ADDENDUM A-02

Project:	Tender No. 22.06.20A - Drumheller Resiliency and Flood Mitigation – Midland Dike Upgrade Project
Addendum:	A-02
Date:	July 11, 2022
Location:	Drumheller, Alberta

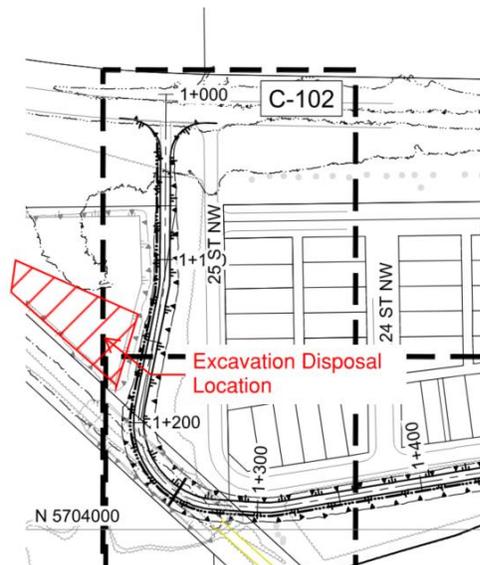
- 8.6 Excavation material is to be disposed of in the parcel of land located west of the flood dike along 25th Street NW as shown in the image below. Note that this land is owned by Alberta Environment and Parks and placement of the material is subject to the issuance of a Temporary Field Authorization. Limit stockpile geometry to 1.5 m in height and slopes no steeper than 3H:1V (horizontal to vertical).

DRUMHELLER RESILIENCY AND FLOOD MITIGATION PROGRAM			
MIDLAND PROPOSED INSTREAM RIPRAP PROTECTION SITE PHOTOS			
Project No.	A03409A05	Drawing No.	C-103
Group	A02	Rev.	A

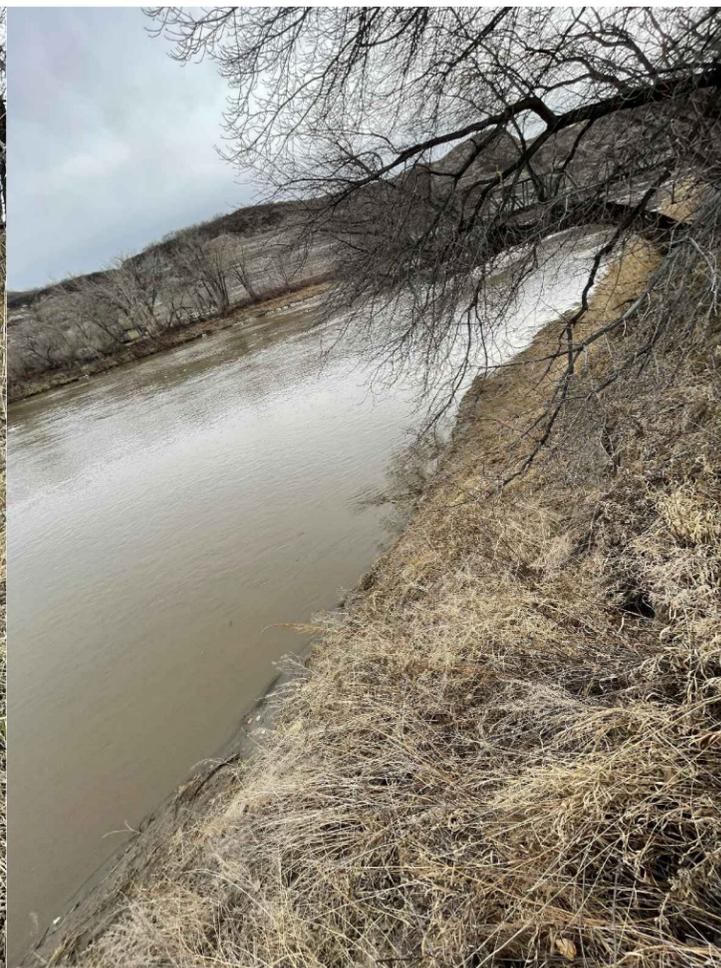
- 8.4 Photos of the shoreline at the location of the instream riprap installation are appended to this Addendum. Care must be taken to minimize the removal of existing riparian vegetation.
